# RUN CHANGES

# 8D3 AMPLIFIER-POWER

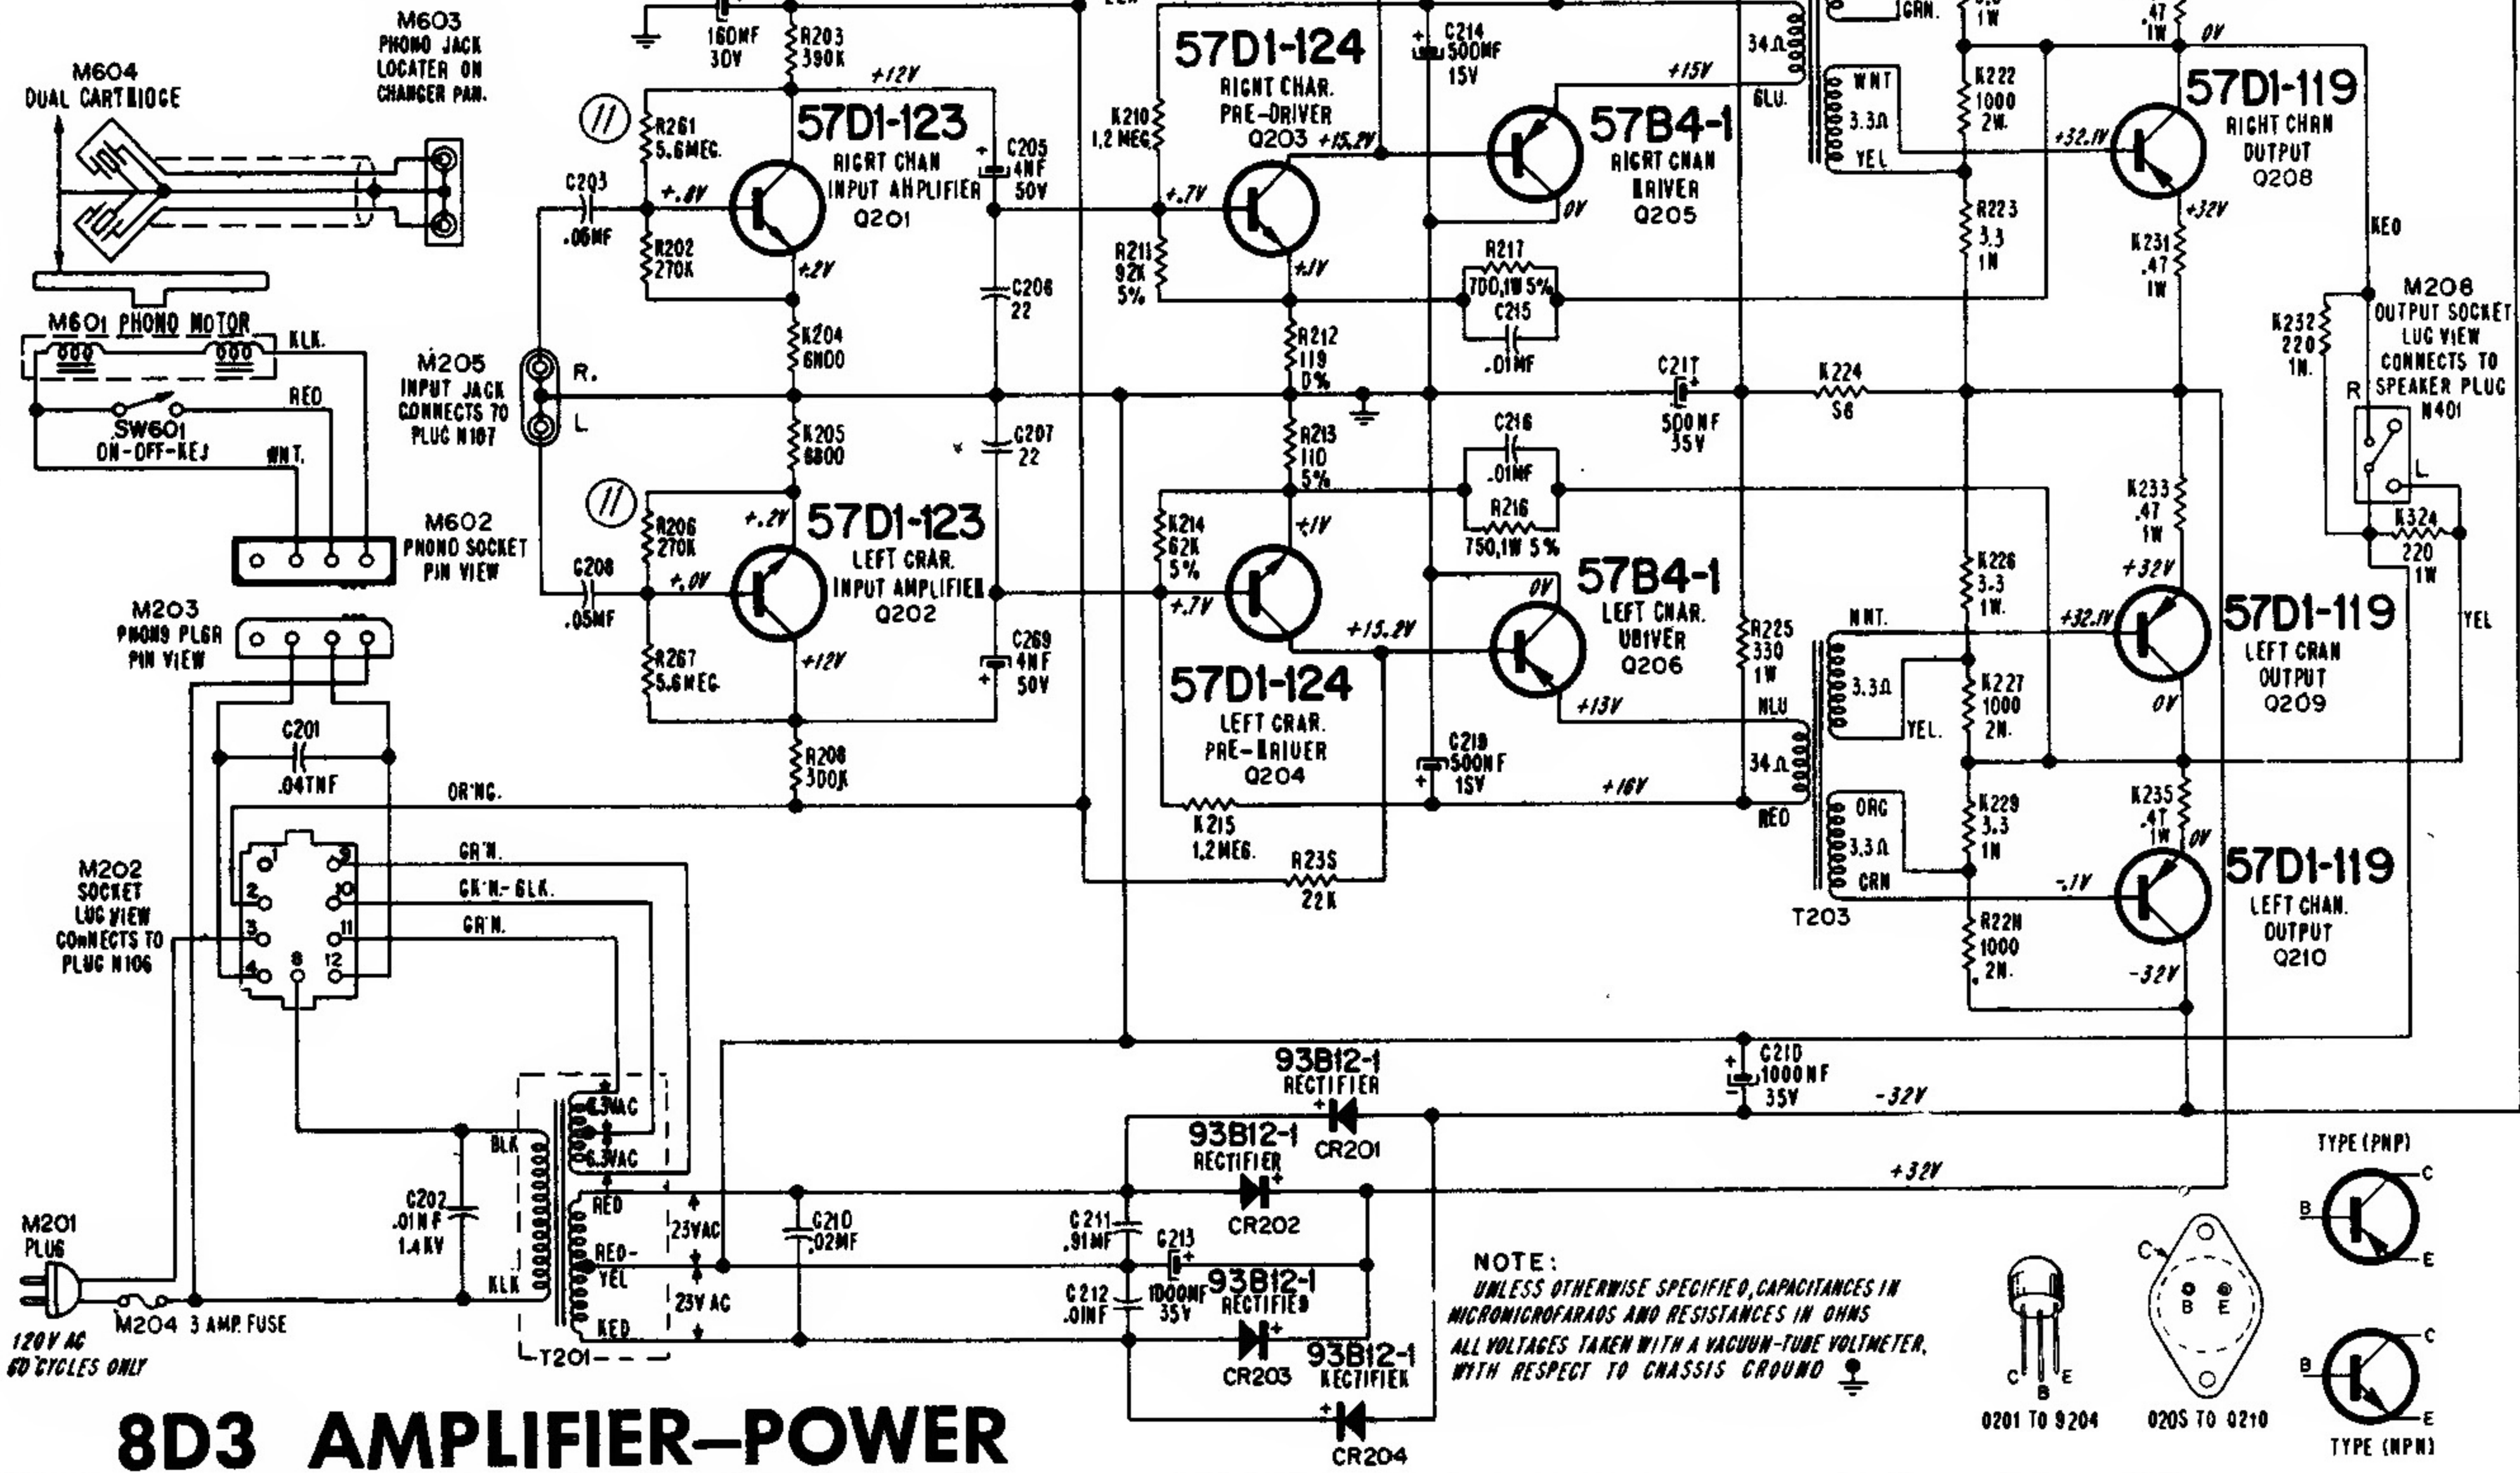
- 10 Start of production
- 11 To improve bass response, C203 & C208 changed from .03mf to .05mf.
